City of Mississauga Department Comments

Date Finalized: 2022-04-13	File(s): A180.22 Ward 11
To: Committee of Adjustment	
From: Committee of Adjustment Coordinator	Meeting date:2022-04-21 1:00:00 PM

Property Address: 4 Kenninghall Blvd

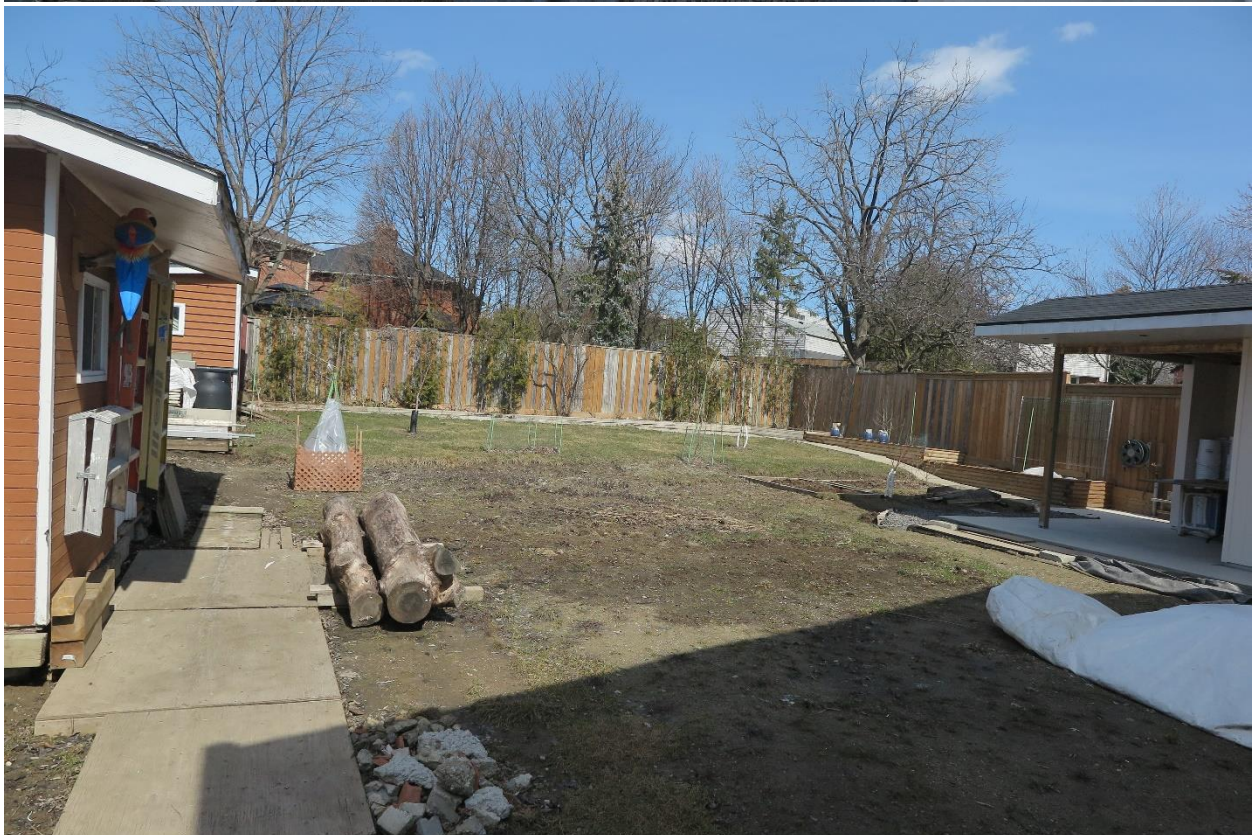
We note from our site inspection that this property has a rear to front drainage pattern where the drainage from the rear yard is directed to the front, preferably on the west side of the property as a drainage swale cannot be constructed on the east side. The applicant has constructed the accessory structure on the east side and installed an eavetrough on the side abutting the immediate neighbour. The downpipe has been buried into the concrete slab and we are not exactly sure where it is discharging.

Should drainage related concerns be expressed by the immediate neighbour to the east, we would then recommend that the downspout be redirected such that any drainage be directed towards the (opposite) westerly property line.

It should also be noted that this property has a reverse grade driveway located on the east side of the dwelling and any additional drainage being directed to this area can create drainage concerns on the reverse grade driveway.
